MEMORANDUM

Subject: Route 119 Comment Responses

The following presents responses to comments received on September 24, 2018.

Town of Greenburgh, NY

Figure 1: Revised Segment 1 Cross Section Recommendation

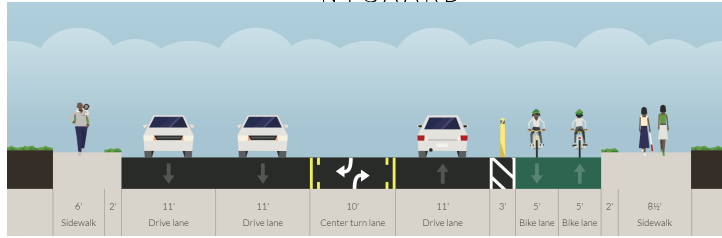
2. *Eastbound from Rt. 9, the jug handle allows two lanes to Rt. 119. Do these two lanes safely transition to one lane?*
 - a. Per the attached diagram and Figure 1 below, two lanes are expected to be kept from the jug handle approach along eastbound Route 119 through the entirety of Segment 1 in order to accommodate traffic volumes. With this layout, the bicycle lanes have been reconfigured as a two-way cycle track along the north curb along the entirety of Segment 1, buffers have been reduced to grass planted strips, and the sidewalk on the south side of Route 119 has been kept at its existing 6 foot width.
